Department of Energy
Oak Ridge Operations APR 21 PM 2 43
P.O. Box E
Oak Ridge, Tennessee 37830

MODIFICATION OF CERTIFICATE OF COMPLIANCE (USA 5939 BF) (YOUR LTR DTD 2/1/80)

Modification of Certificate of Compliance (USA 5939 BF)

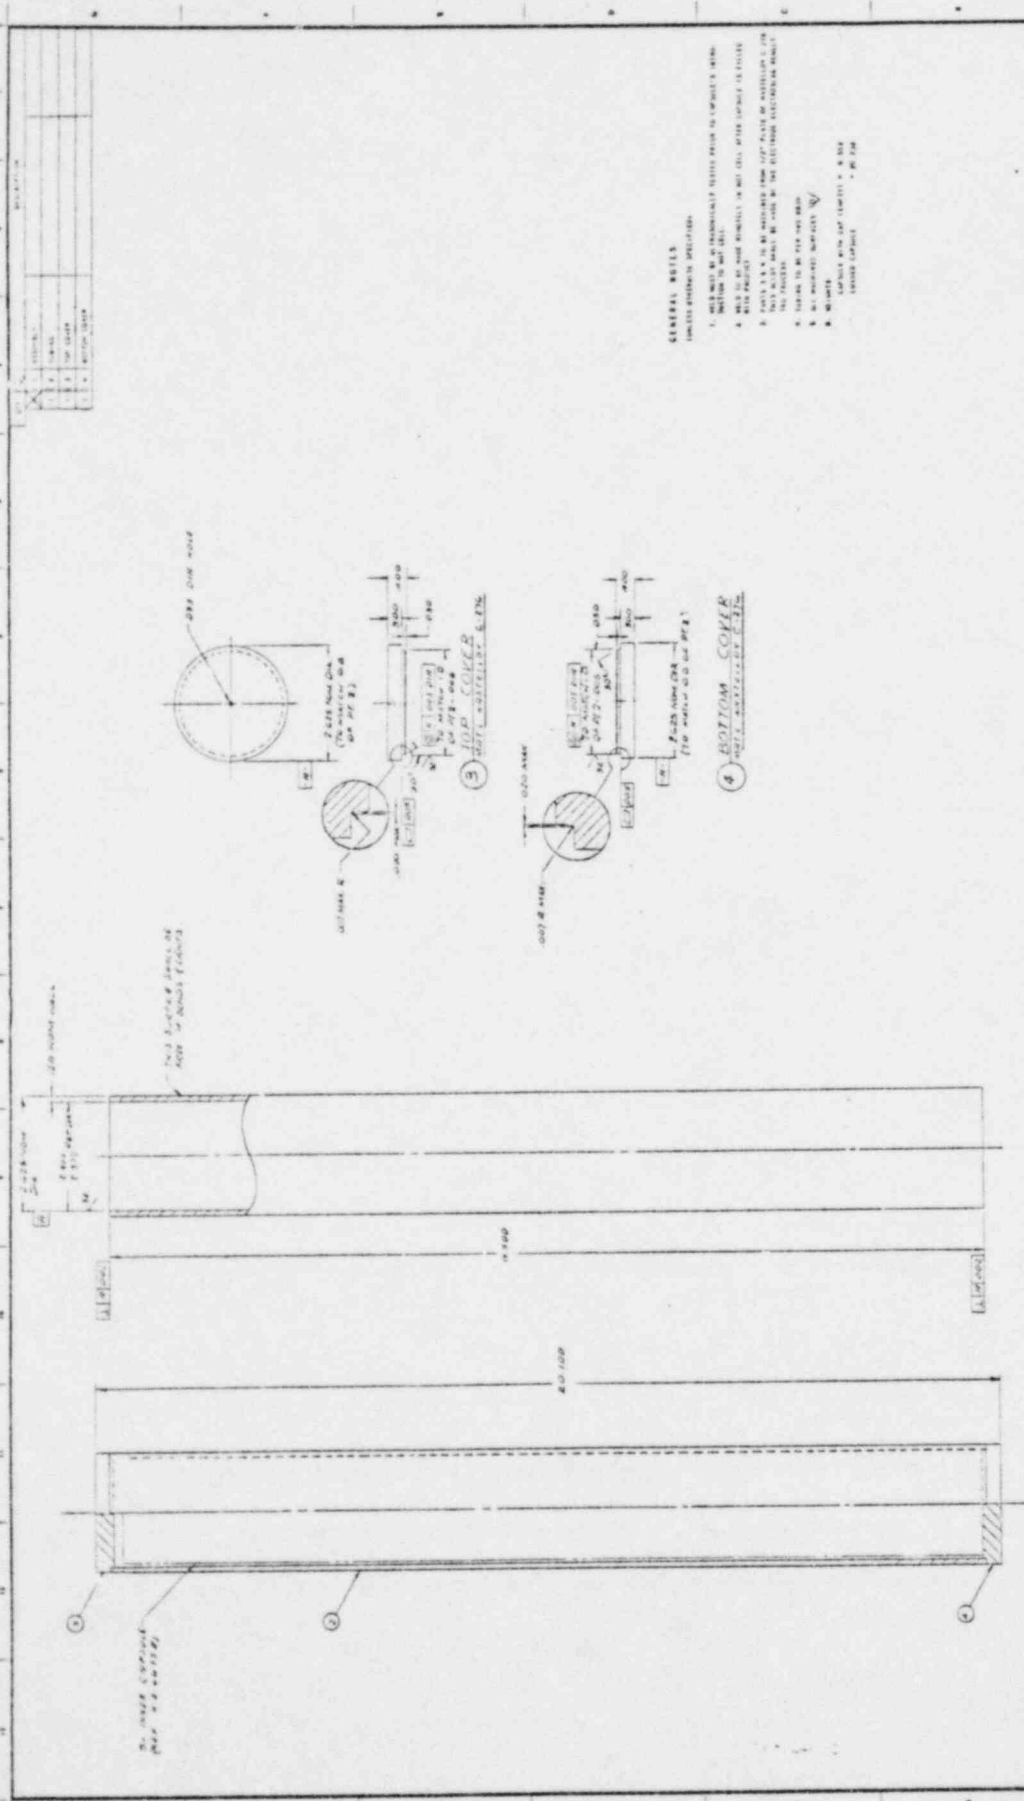
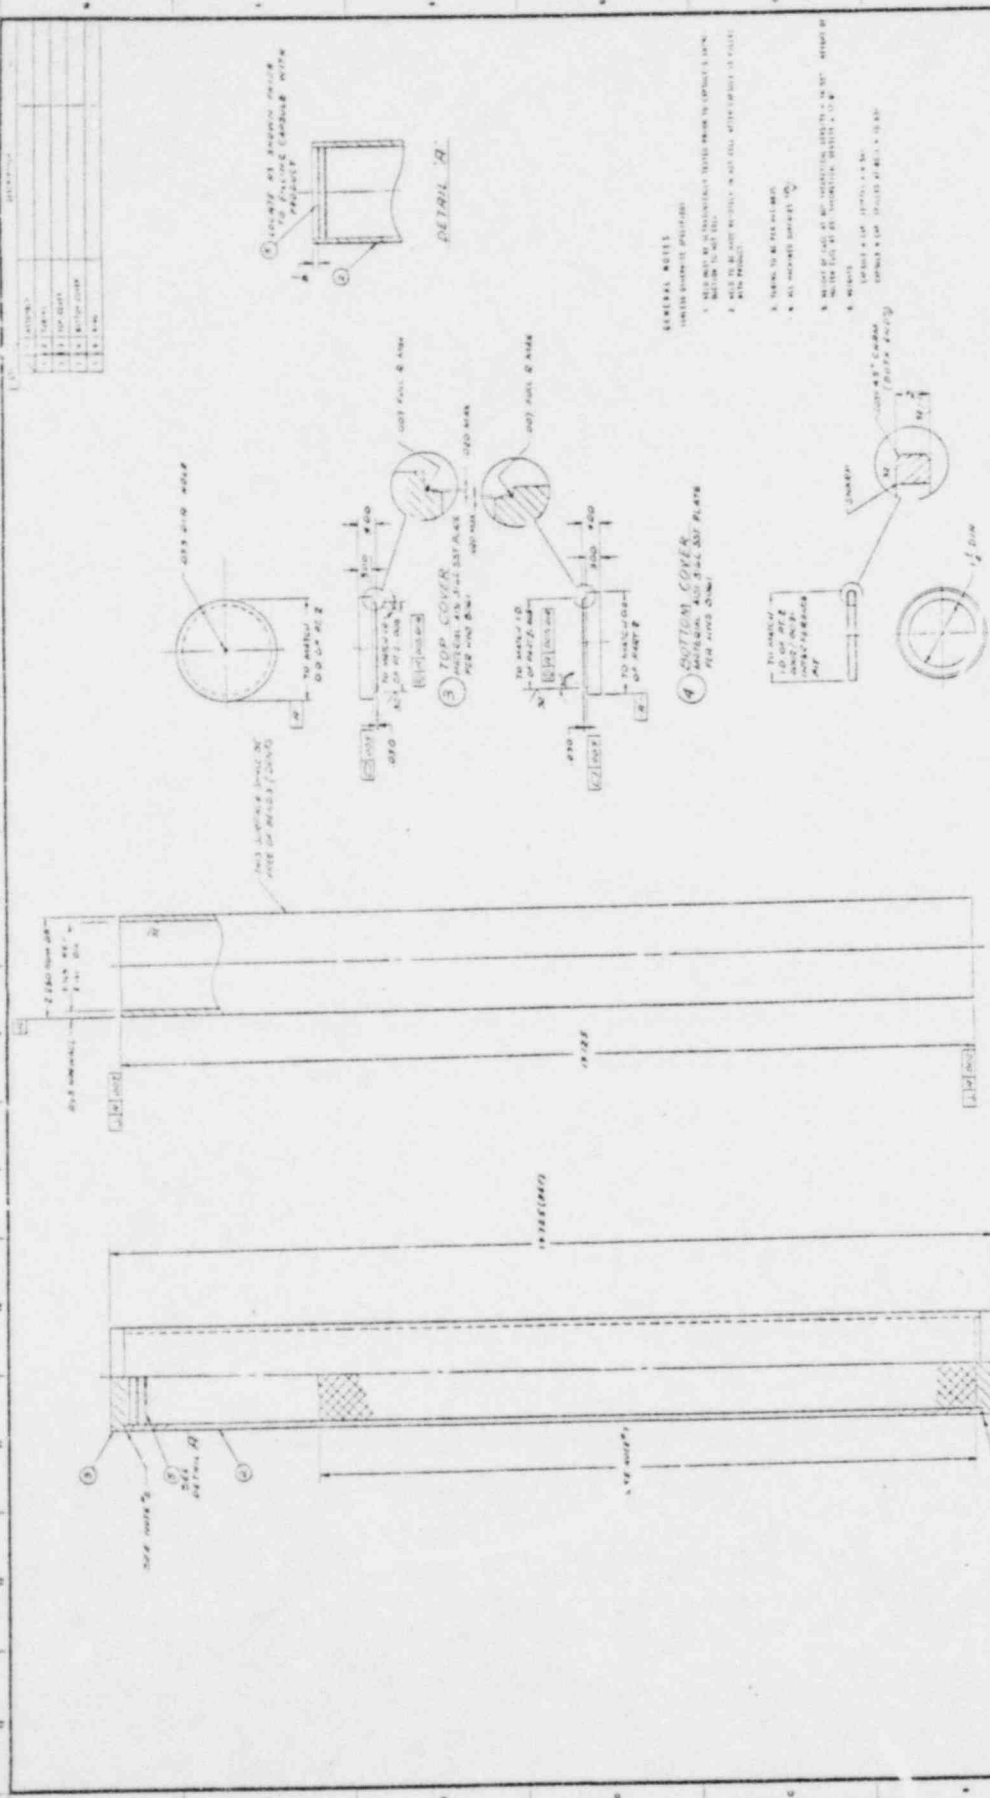
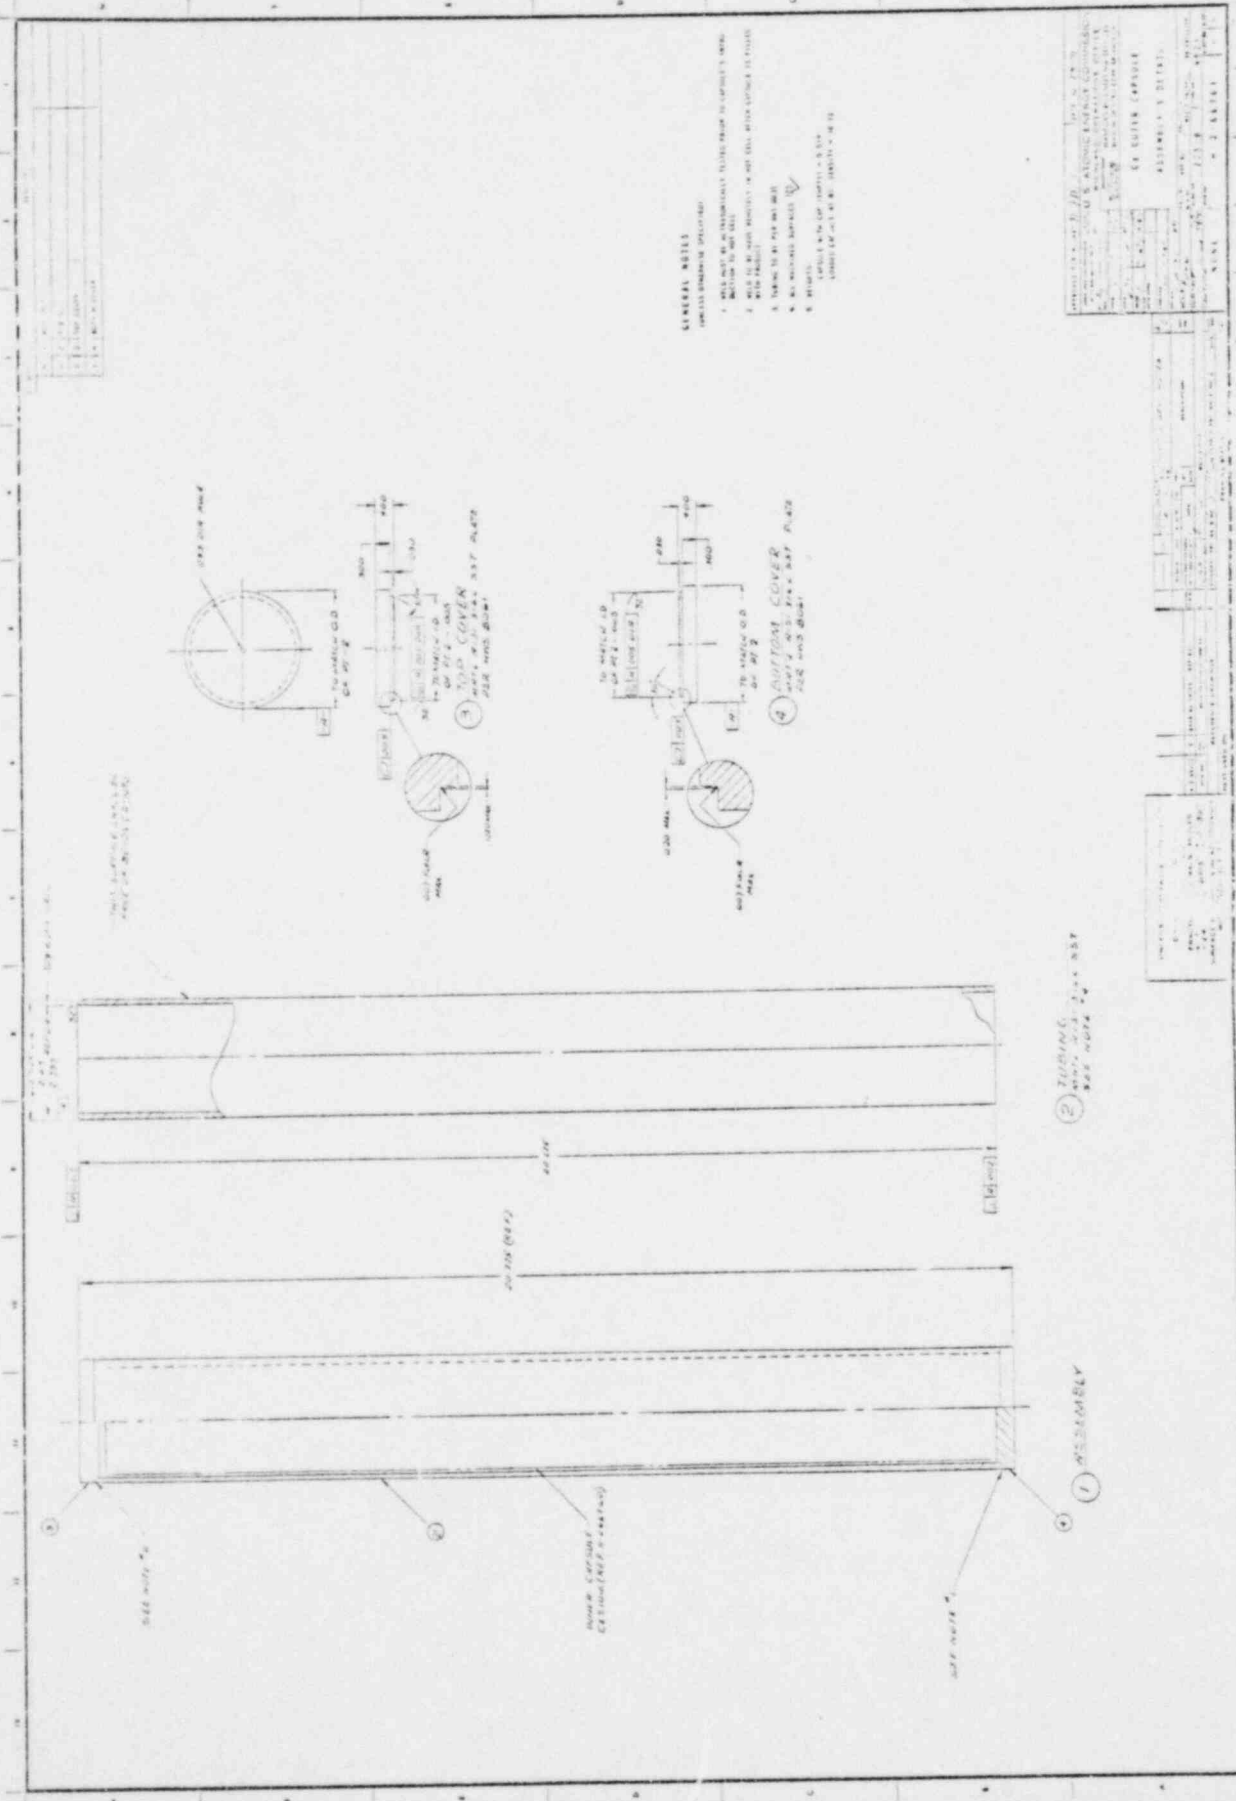
The WESF capsules used for $^{90}\text{SrF}_2$ and $^{137}\text{CsCl}$ (attached drawings) are identical in closure design and outside diameters of both the inner and outer containers; the $^{137}\text{CsCl}$ capsule is 0.075 inches longer than the $^{90}\text{SrF}_2$ capsule. The $^{137}\text{CsCl}$ capsule is fabricated of Type 316L stainless steel. The $^{90}\text{SrF}_2$ capsule is fabricated of "Hastelloy C-276" high-temperature alloy, and the walls of the inner and outer containers are thicker (0.025 inches and 0.011 inches) than the corresponding $^{137}\text{CsCl}$ capsule walls. Cesium chloride has a lower melting point (646°C) than SrF_2 (1450°C) and also exhibits a larger thermal expansion. For these reasons the $^{137}\text{CsCl}$ capsule design was selected for testing to demonstrate leak tightness (Regulatory Guide 7.4). By analysis, if the $^{137}\text{CsCl}$ design passes all applicable tests the $^{90}\text{SrF}_2$ would also be qualified.

A capsule containing inert cesium chloride was fabricated at RHO under conditions which simulated as closely as possible those used in fabrication of the $^{137}\text{CsCl}$ capsules. The capsule was shipped to ORNL and subjected to the series of special form tests prescribed in Safety Series No. 6, Regulations for the Safe Transport of Radioactive Materials, 1973 Revised Edition, IAEA, Vienna, 1973 and in 49CFR 173.398 (a). These tests included a 30-ft. drop test, an impact test, and a high-temperature (800°C) test. Before and after each test the capsule was leak tested using both an ethylene glycol-vacuum test described in Leak Testing of Radioactive Sources, ORNL-4529, and a helium leak test was made at a sensitivity of $< 1 \times 10^{-8}$ STD cc/sec. No leaks were detected in any of the tests and the capsule sustained no visible structural damage. Records of these tests are on file at ORNL. The $^{90}\text{SrF}_2$ and $^{137}\text{CsCl}$ capsules loaded at RHO are helium leak tested after fabrication (leak test sensitivity $< 1 \times 10^{-8}$ ST) cc/sec), and they are checked for surface contamination immediately prior to shipment as additional demonstration that no leaks are present.

We conclude that since the prototype capsule of the $^{137}\text{CsCl}$ design passed all applicable special form tests the $^{90}\text{SrF}_2$ design would also. We would appreciate your obtaining the modified Certification of Compliance.
